**SHUMWAY - MIXED USE**

1082 S MAIN STREET MOAB, UT 84532		NOT FOR CONSTRUCTION
<b>REVISIONS:</b>	PRE SITE PLAN APP	
24 03 22	SITE PLAN APPL	
24 06 10	SITE PLAN REV#1	
25 09 24	SITE PLAN REV#2	
25 11 10	SITE PLAN REV#2

## P&Z COMMENTS - SITE PLAN REV 2

DRT COMMENT RESPONSE REPORT TO #24-0029\_SHUMWAY 1082 HWY 191 SITE PLAN ROUND 2  
RECEIVED FROM JOHANNA BLANCO, 10/08/2025

SHEET NAME: **SITE PLAN**  
 SHEET NUMBER: **A001**

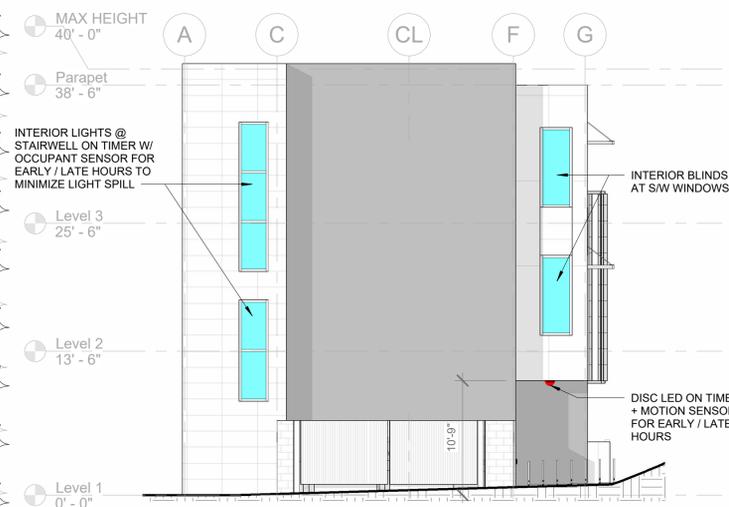
i. Please mitigate light directed off the property on the southwest side with a shield or through other measures 17.09.063(B)  
RESPONSE:

ii. Buffering 17.10.050 A - Please show 8-foot screening in zone suffering area.  
RESPONSE: REFER TO SHEET 'A001' SITE PLAN. AN 8-FT OPAQUE FENCE SHALL BE PROVIDED AT THE REAR PROPERTY LINE, PROVIDING THE REQUIRED 8FT SCREENING BETWEEN THE NON-RESIDENTIAL PROPERTY AND THE ADJACENT RESIDENTIAL ZONE. VERBIAGE ON THIS SHEET IN THE RIGHT HAND SECTION OF COMMENTS HAS ALSO BEEN UPDATED TO CLARIFY THAT THE 17.10 BUFFERING & SCREENING REQUIREMENTS ARE COMPLIED WITH. 8FT FENCE TO COMPLY WITH ANY & ALL CITY OF MOAB STANDARDS, FINAL DESIGN TBD W/ CONTRACTOR.

- AN 8FT HIGH OPAQUE FENCE IS NOW PROVIDED AT THE SOUTHWEST PROPERTY LINE TO PROVIDE SCREENING, WHICH WILL FURTHER SHIELD ANY LIGHT SPILL. (REF SHEET 'A001')

SHEET NAME  
**EXTERIOR LIGHTING & SIGNAGE**

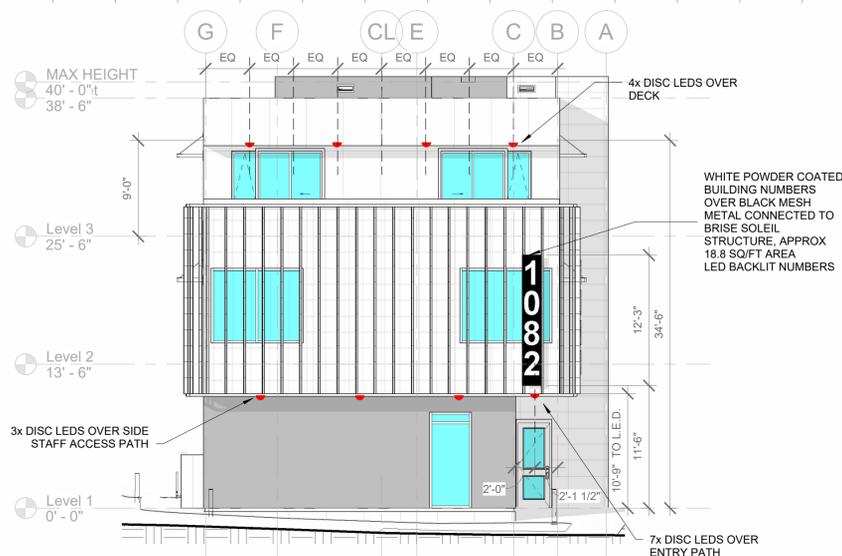
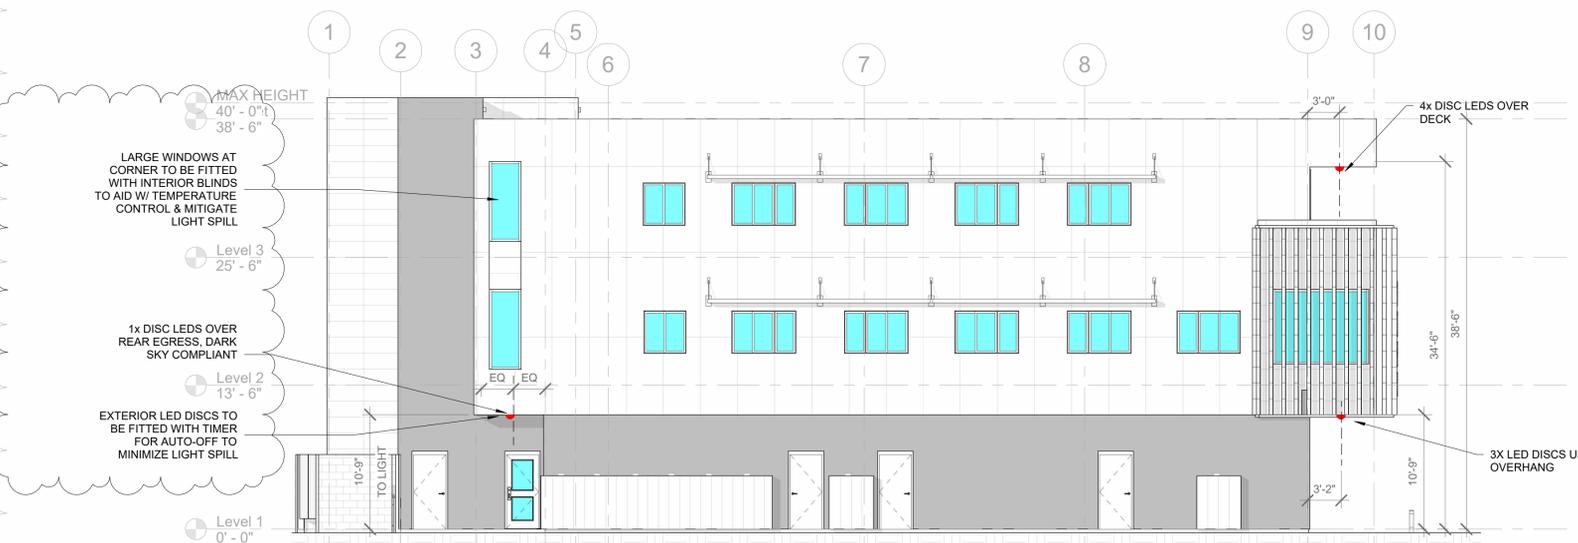
ii. The outdoor lighting appears to be compliant with the outdoor lighting code. 17.09.068(A)(3) states a photometric plan is required for commercial lighting. However, it states that in the absence of a plan that details must be provided for evaluation. Since all lighting is recessed on the building and shielded, it is unlikely they would direct illumination off the property. If the sign is lit, then the lights must be compliant, and the associated lumens added to the total.

RESPONSE: SITE LIGHTING PLANS HAVE BEEN UPDATED. ADDITIONAL DARK-SKY COMPLIANT AND FULL SHIELDED BOLLARD LIGHTING HAS BEEN ADDED TO THE PARKING LOT AND LANDSCAPED AREAS. LED LIGHTS AT THE BUILDING NUMBER AND MONOLITH SIGN HAVE BEEN ADDED TO THE CALCULATIONS. ALL FIXTURES ARE STILL DARY SKY COMPLIANT AND BELOW THE LIMIT, PER MOAB CITY 17.09 REGULATIONS. A PHOTOMETRIC PLAN IS NOW ALSO PROVIDED WITH SUBMISSION DOCUMENTS BY AN ELECTRICAL ENGINEER. SIGNAGE WILL HAVE LIGHTING DETAILED FURTHER WITH DEFERRED SIGN PERMIT SUBMITTAL.

**AREA PLANS A050**

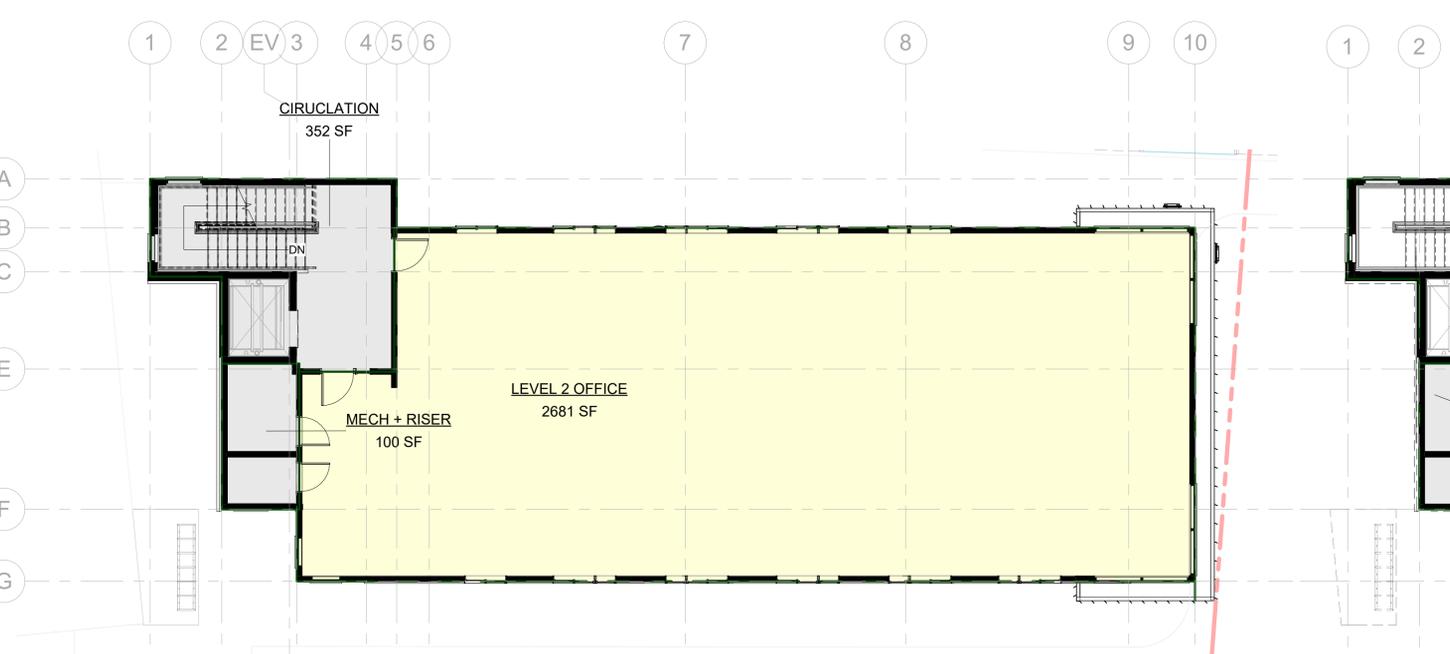
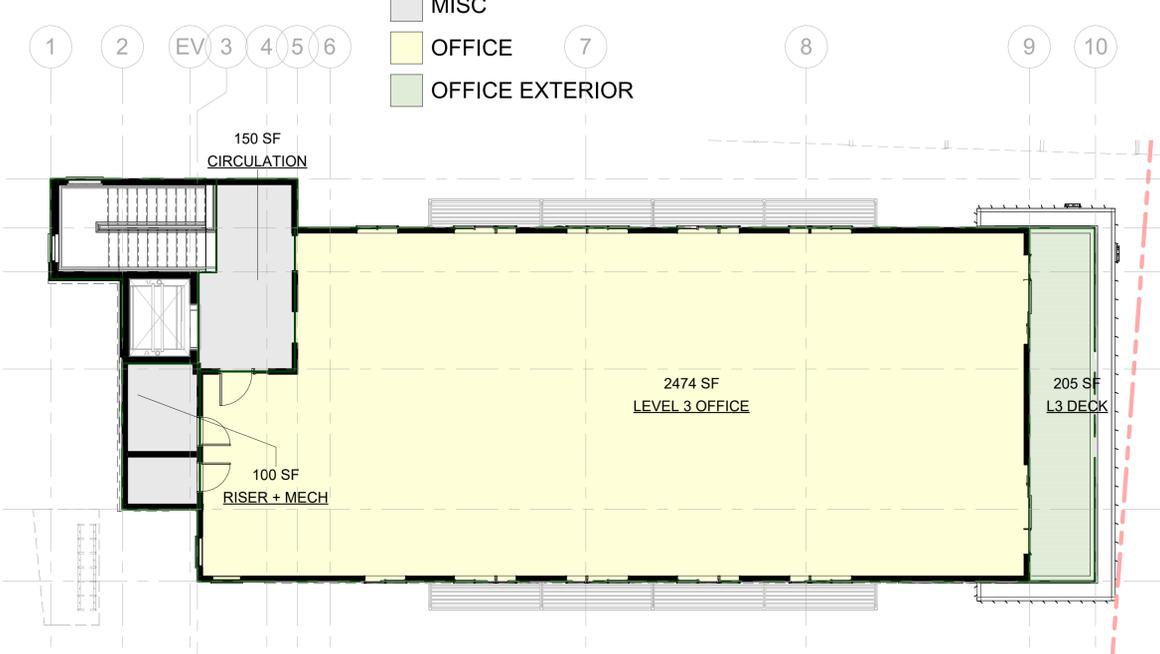
i. Please redo the parking calculation with the 1st floor hall and bathroom fully assigned to the Retail use. I believe this will result in 29 parking spaces without dividing spaces into multiple uses.  
RESPONSE: REFER TO SHEET 'A050'. CALCULATIONS HAVE BEEN UPDATED PER DRT COMMENT. SPACES NO LONGER DIVIDED INTO MULTIPLE USES. HOWEVER, THIS DOES NOT ACTUALLY CHANGE THE NUMBER OF REQUIRED PARKS. AMOUNT OF PARKING REQUIRED IS STILL 29.9 SPACES, I.E. 30 SPACES - AS PROVIDED.

SHEET NUMBER  
**A101**

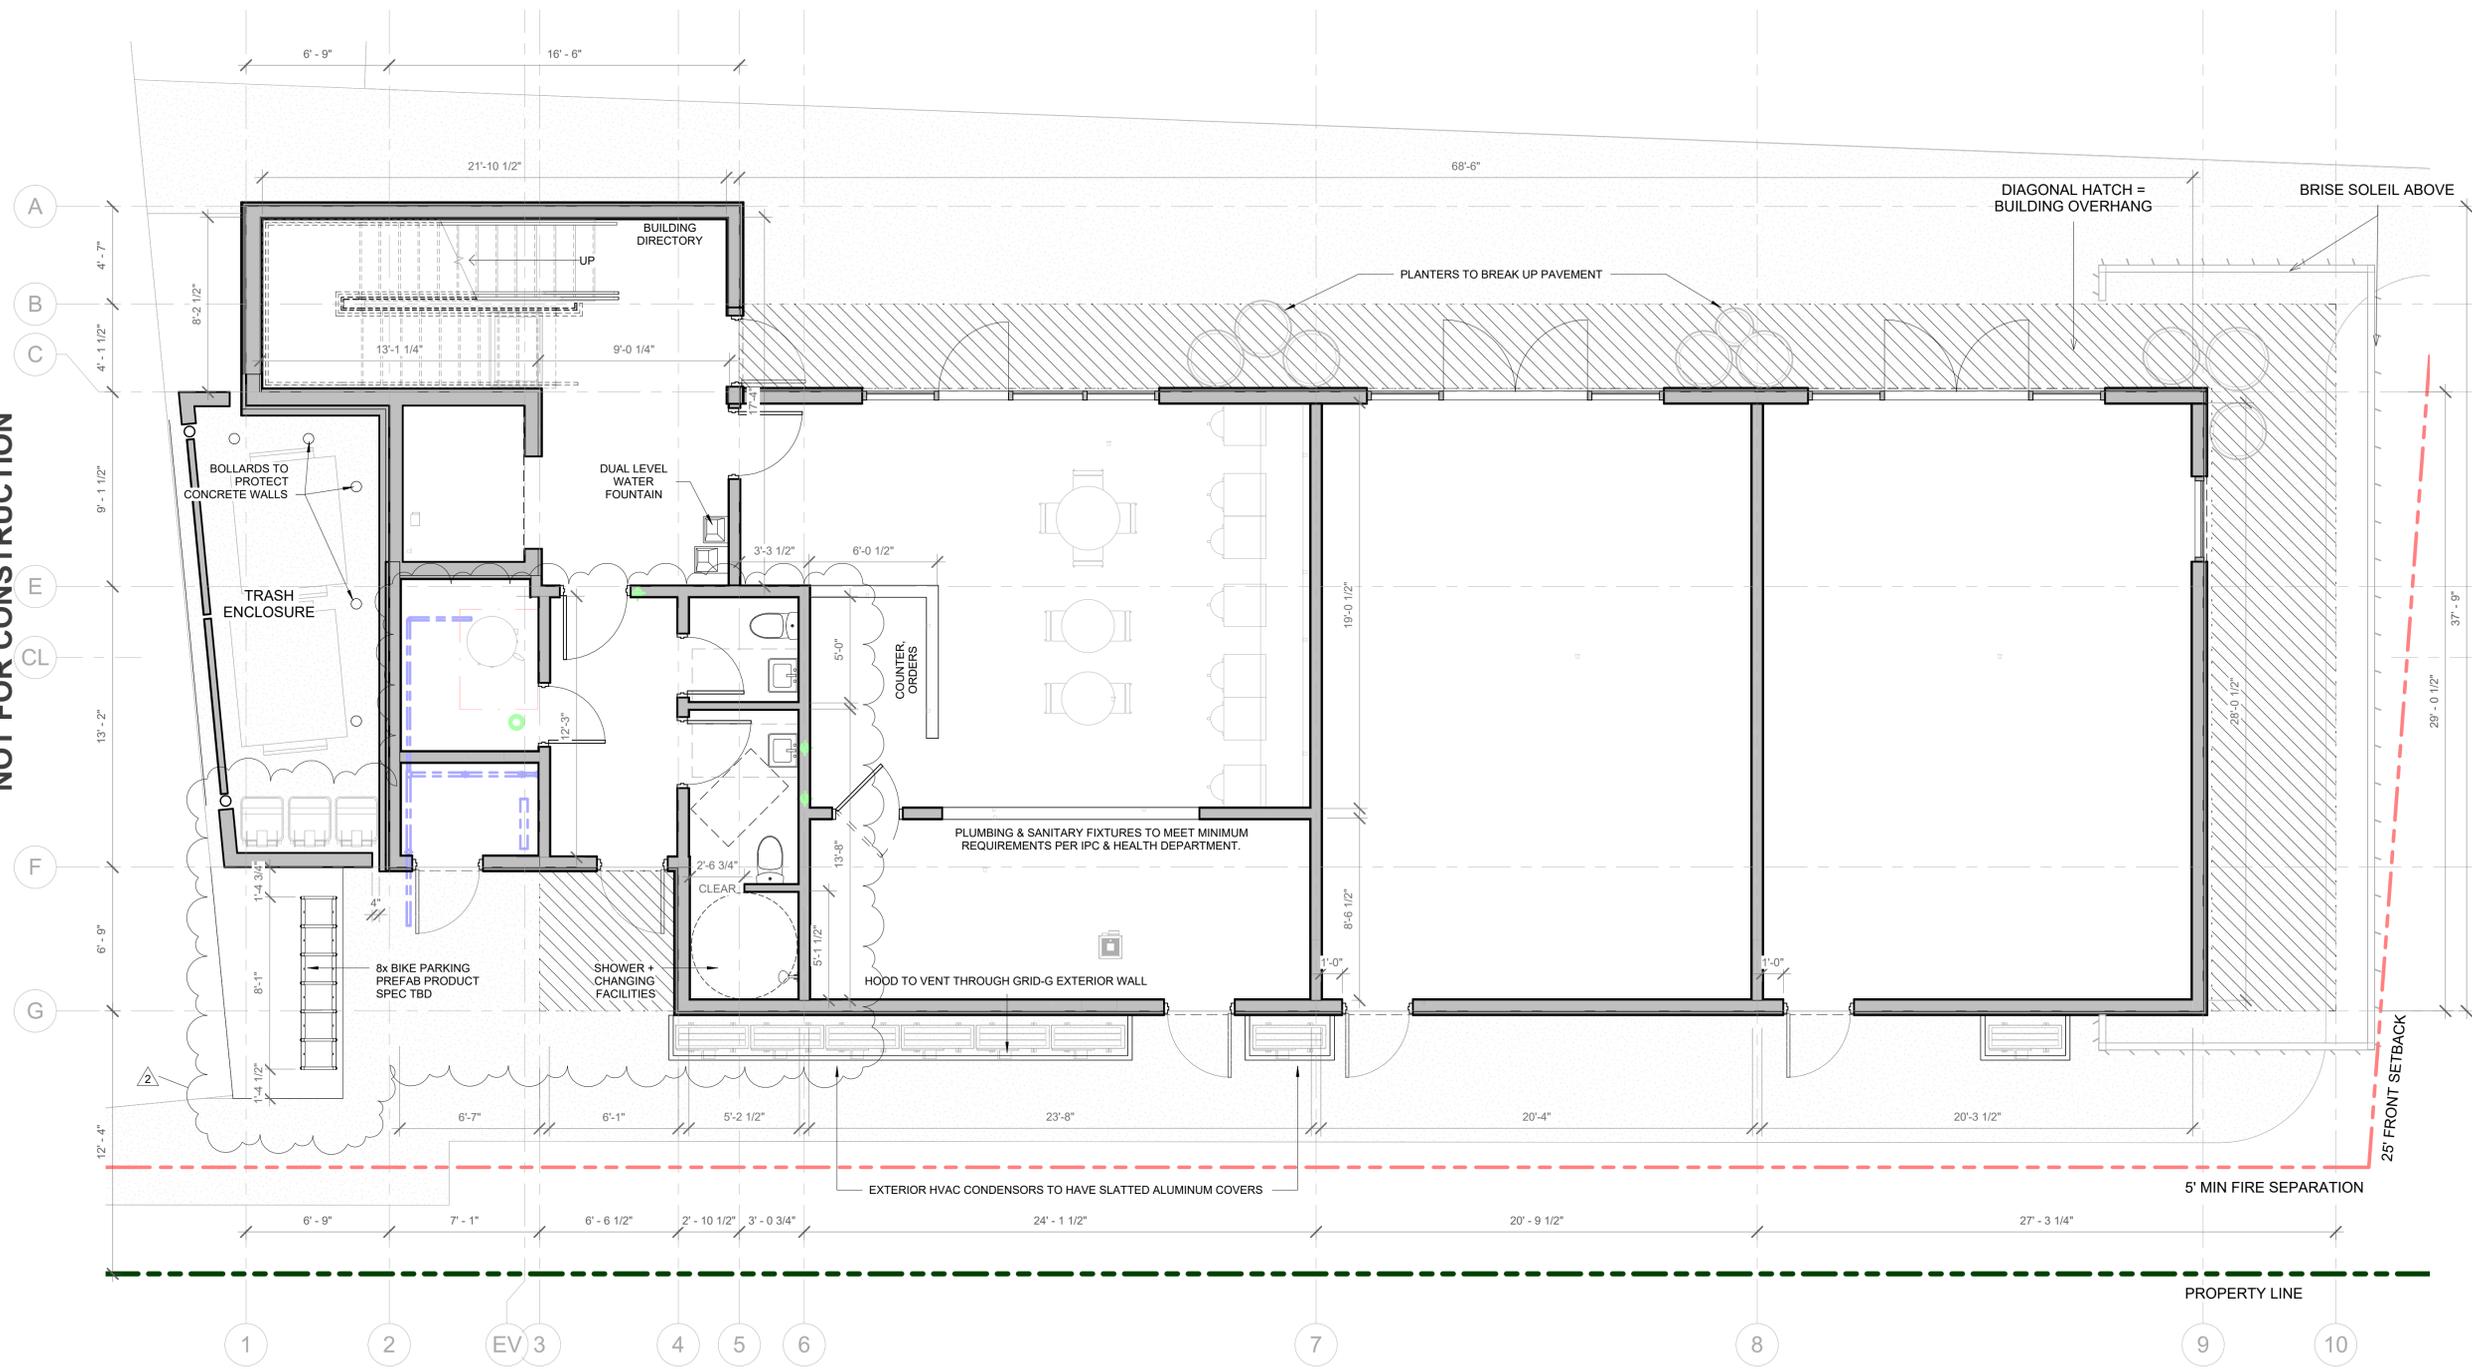
v. Pre-Annexation Agreement requirements: Please include the following required by section 6.3: bicycle facilities  
RESPONSE: 8x BICYCLE STORAGE SPACES HAVE BEEN ADDED TO THE SITE PLAN (REF A001 & CIVIL DRAWINGS), PROVIDING 4x TEMPORARY BIKE SPACES AND 4x REGULAR OCCUPANT BIKE SPACES. AS REQUIRED BY PRE-ANNEXATION AGREEMENT PER THIS REQUIREMENT, A SHOWER AND CHANGING FACILITY AS ALSO BEEN ADDED ON SITE. THIS SHOWER IS AN ADA-COMPLIANT ROLL-IN SPEC. REFER TO SHEET 'A101' FOR THESE CHANGES.
